Re: State of Tennessee perspective on letter from John A. Mullis to Andrew R. Wheeler dated April 5, 2019, Appeal of U.S. Environmental Protection Agency's Region IV position regarding water discharge limits for radionuclides

Re: State of Tennessee Position in the Formal Dispute Initiated by the U.S. Environmental Protection Agency on August 24, 2018, on the *Focused Feasibility Study for Water Management for the Disposal of CERCLA Waste on the Oak Ridge Reservation, Oak Ridge, Tennessee* (DOE/OR/01-2664&D2)

RE: Focused Feasibility Study [FFS] for Water Management for the Disposal of CERCLA Waste on the Oak Ridge Reservation, Oak Ridge, Tennessee (DOE/OR/01-2664&D2)

Explanation of Significant Differences for the Record of Decision for the Disposal of Oak Ridge Reservation Comprehensive Environmental Response, Compensation, and Liability Act of 1980 Waste, Oak Ridge, Tennessee (DOE/OR/01-2322&D1)

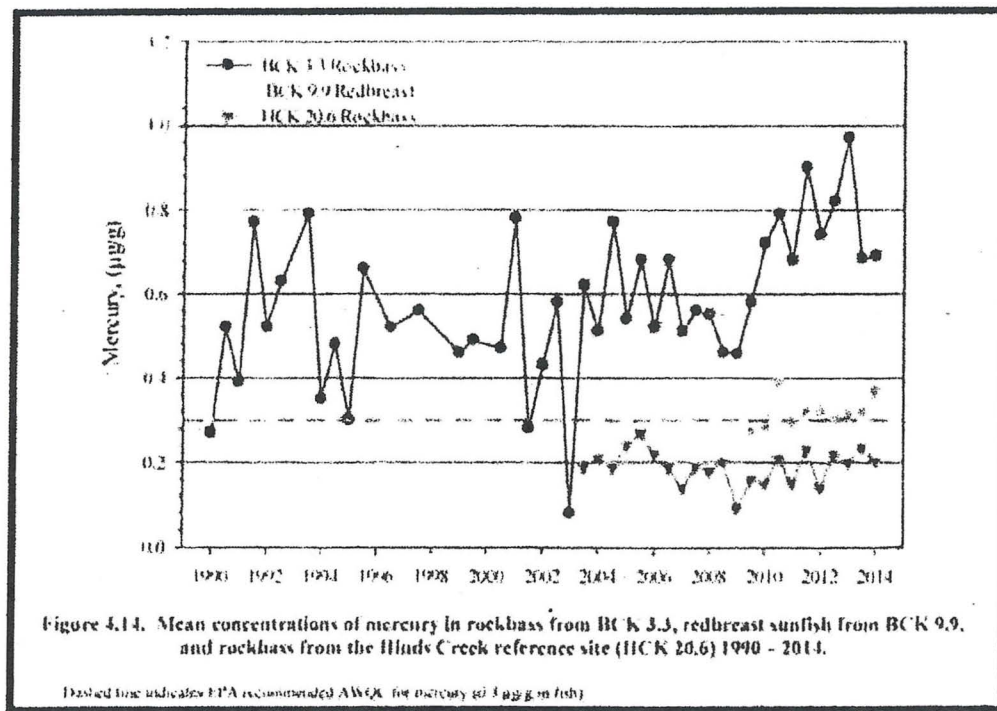
This graph indicates something changed after 2009 causing an increase in concentrations of mercury in downstream Rockbass. The data show that four of eleven samples (36%) collected since 2009 are greater than or equal to the highest levels observed since 1990. This trend is disturbing in light of the fact that DOE proposes to construct another disposal facility in Bear Creek Valley that would potentially receive additional mercury bearing waste from demolition of facilities in the West End Mercury Area (WEMA) at Y-12.

- 1) A detailed schedule for resolution of issues associated with water management at the EMWMF and proposed EMDF; and
- 2) Discharge limits for chemical and radiological contaminants that are consistent with CERCLA, DOE Orders and ARARs; and
- 3) A plan to identify and correct discharges of mercury above allowable limits.
